Susuka Knit Ltd. (10831)

13.AUGUST.2014

Identified Priority 3 Concerns

2nd Priority 3 Concern

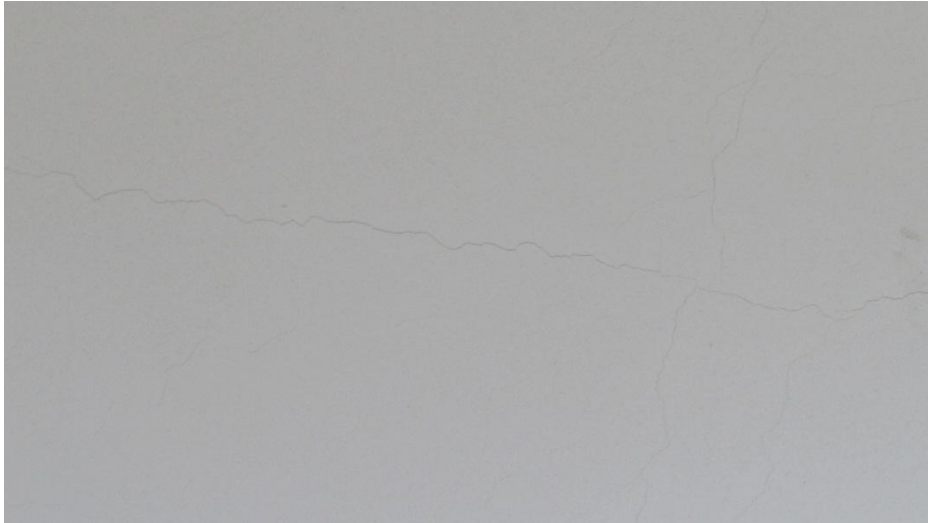
The current roof level needs to be protected with a water proofing layer if construction is not continued within the next three months.

4th Priority 3 Concern

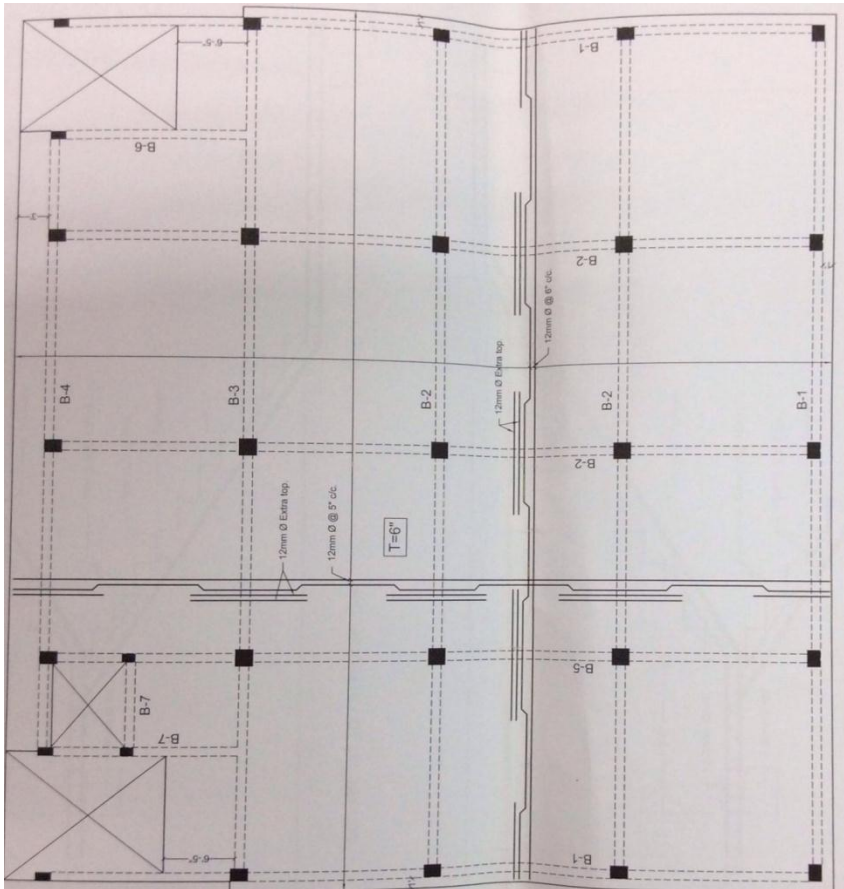
The cracking on the 3rd floor beams and slabs needs to be investigated to determine whether they are plaster cracks or structural cracks.
